Colorado Interstate  
Gas Company, L.L.C.  
a Kinder Morgan company

Re: Colorado Interstate Gas Company, L.L.C.;  
Docket No. CP19-56-000;  
Supplemental Environmental Information

COLORADO INTERSTATE GAS COMPANY, L.L.C.  
Response to OEP Data Request  
Dated February 21, 2019 in Docket No. CP19-56-000  
CIG High Plains Kiowa Lateral Expansion Project

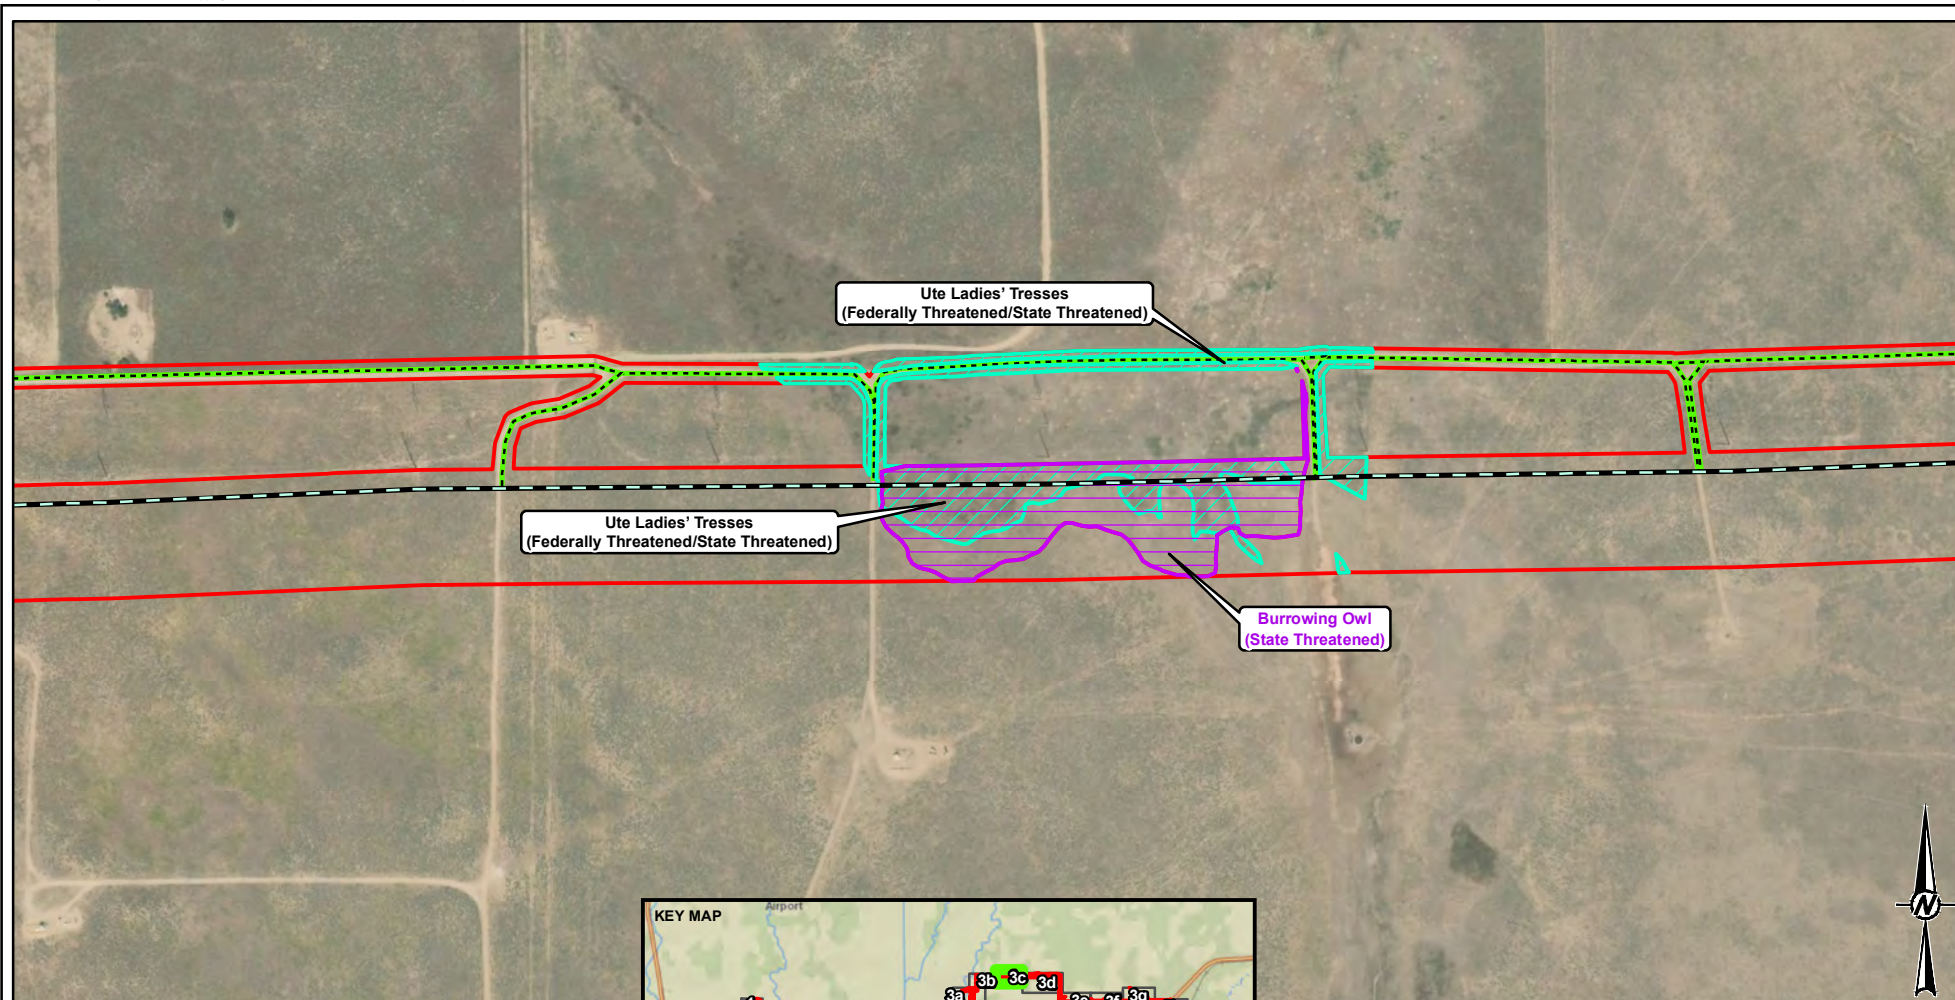
2. Within the project survey area is the black-footed ferret habitat considered a federally endangered/state endangered?

For the proposed project survey area the habitat for the black-footed ferret is not considered to be federally endangered/state endangered. CIG is providing an updated threatened and endangered species potential habitat map (see attached Figure 3C in Appendix C) that removes references to the black-footed ferret habitat.
